Model: AT-C2.5	Date: 22-Oct-10	No.: RD087001n
----------------	-----------------	----------------

Subject: Firmware Release Note: System/Copy		Prepared by: Y. Taniguchi	
From: 1st Tech Service Sect., MFP/Printer Tech Service Dept			
Classification:	<input type="checkbox"/> Troubleshooting <input type="checkbox"/> Mechanical <input type="checkbox"/> Paper path <input type="checkbox"/> Product Safety	<input type="checkbox"/> Part information <input type="checkbox"/> Electrical <input type="checkbox"/> Transmit/receive <input checked="" type="checkbox"/> Other (Firmware)	<input type="checkbox"/> Action required <input type="checkbox"/> Service manual revision <input type="checkbox"/> Retrofit information <input checked="" type="checkbox"/> Tier 2

This RTB has been issued to announce the firmware release information for the **System/Copy**.

**Reissued:15-Feb-11**
**Model: AT-C2.5**
**Date: 25-Nov-10**
**No.: RD087014a**
***Additional reference:***
***This machine has two types of NVRAM.***
***(1) NVRAM on the BICU***

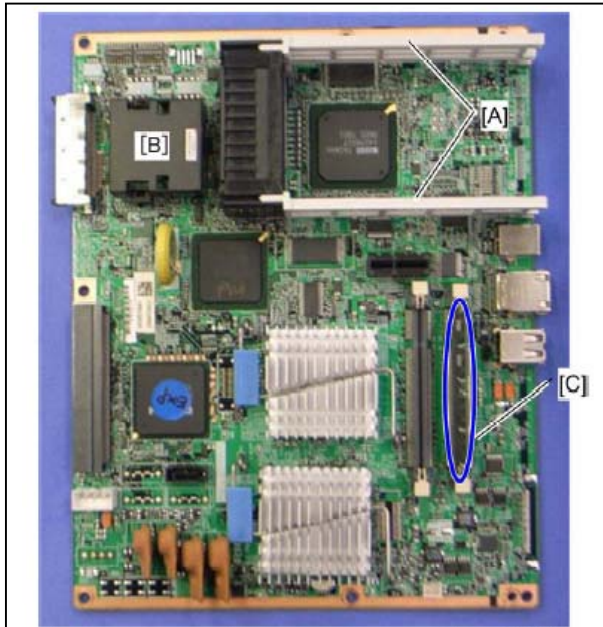
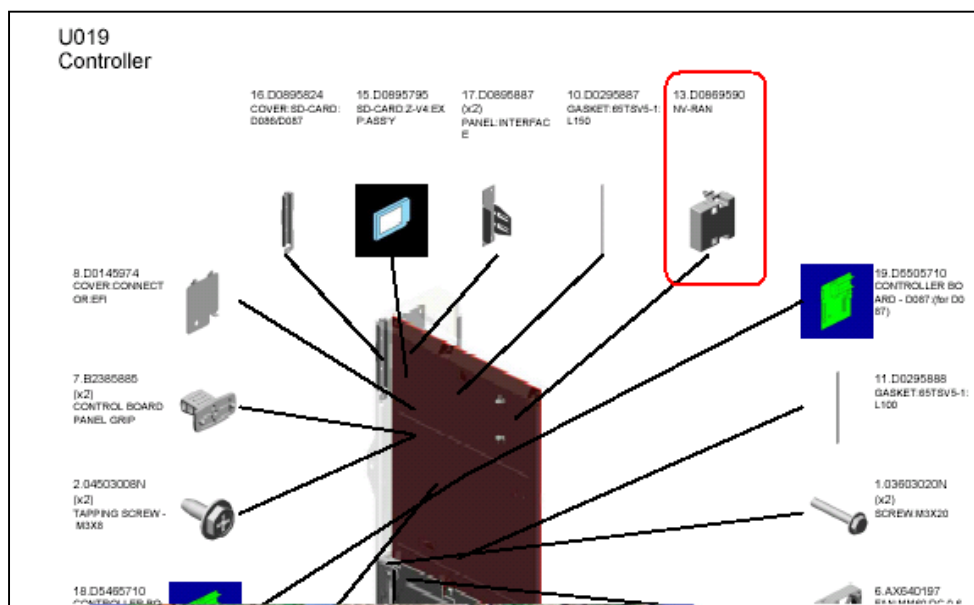
The ***NVRAM*** replacement procedure contained in the Service Manual ***should be*** revised. ***In addition to the existing procedure, whose title is "NVRAM on the BICU", please add the procedure, whose title is "NVRAM on the Controller Board".***

***The NVRAM on the BICU is shown above as [B] on the BICU board [A] (See Pg. 313 in the FSM)***

**The NVRAM on the Controller Board is shown as [B] in the above photograph (See Pg. 318 in the FSM).**

### Production line

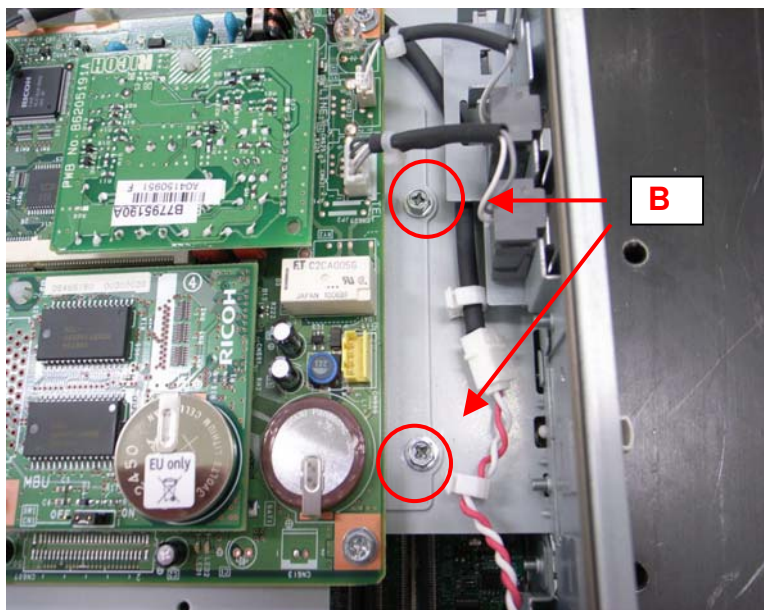
The screw [A] was shortened and the shape of the two screws [B] fixing the plate in place was changed.

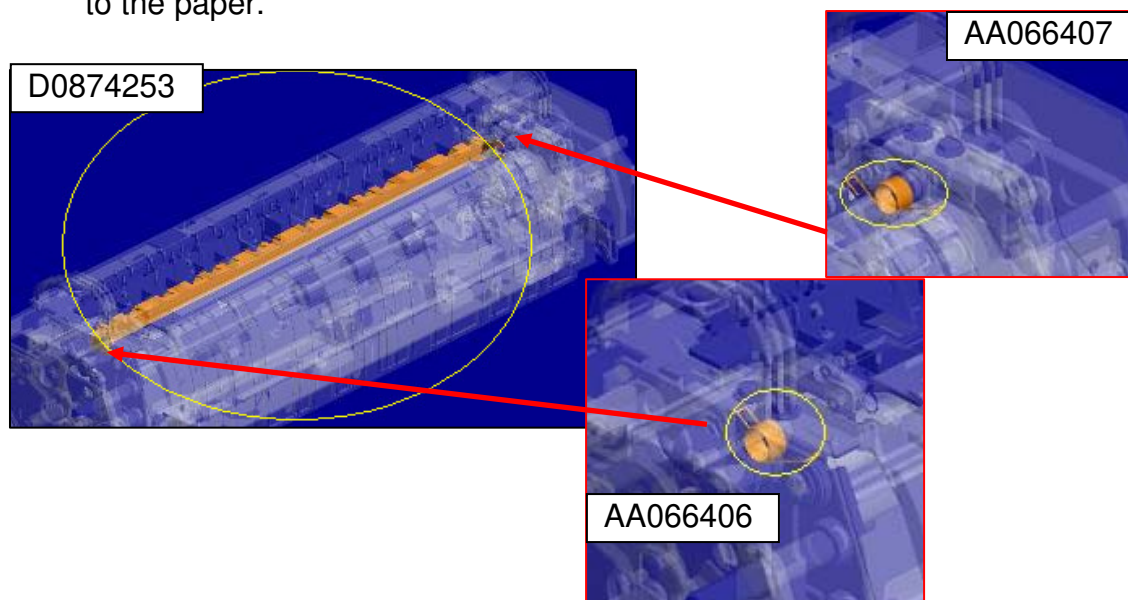
Old part number	New part number	Description	Q'ty	Int	Page	Index	Note
<b><i>D0874020</i></b>	<b><i>D0874021</i></b>	<b><i>FUSING UNIT:NA:MAINTENANCE:ASS'Y</i></b>	<b><i>1</i></b>	<b><i>X/O</i></b>	-	-	-
<b><i>D0874016</i></b>	<b><i>D0874040</i></b>	<b><i>FUSING UNIT:TWN:MAINTENANCE:ASS'Y</i></b>	<b><i>1</i></b>	<b><i>X/O</i></b>	-	-	-
D0874035	D0874036	FUSING UNIT:EU:MAINTENANCE:ASS'Y	1	X/O	-	-	-
D0874253	-	STRIPPER PLATE:PRESSURE ROLLER	1	X/X As a set	-	-	-
AA066406	-	COIL SPRING:STRIPPER PLATE:PRESSURE:FRONT	1		-	-	-
AA066407	-	COIL SPRING:STRIPPER PLATE:PRESSURE:REAR	1		-	-	-
D0894251	D0874251	GUIDE PLATE:FUSING EXIT:RIGHT	1		-	-	-
D0894252	D0874252	GUIDE:FUSING EXIT:PFA	6		-	-	-

**Change:** 1) The stripper plate and two of its coils were deleted.

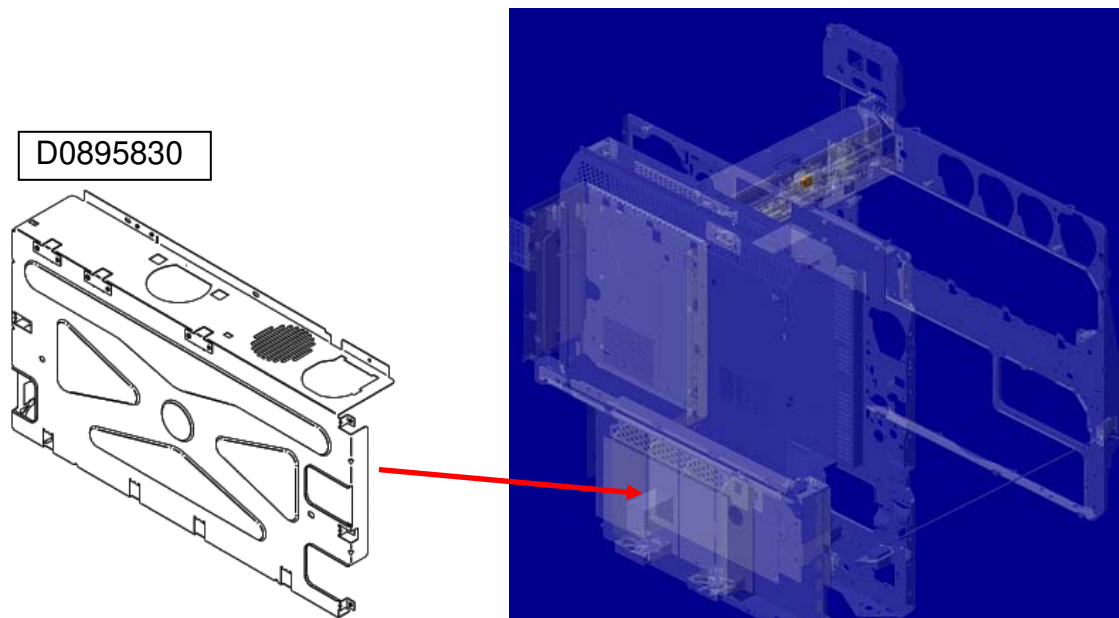
Old part number	New part number	Description	Q'ty	Int	Page	Index	Note
-	D0895830	BRACKET:PSU:ASS'Y	1	-	-	-	-

**Change:** The PSU bracket was added as a service part.
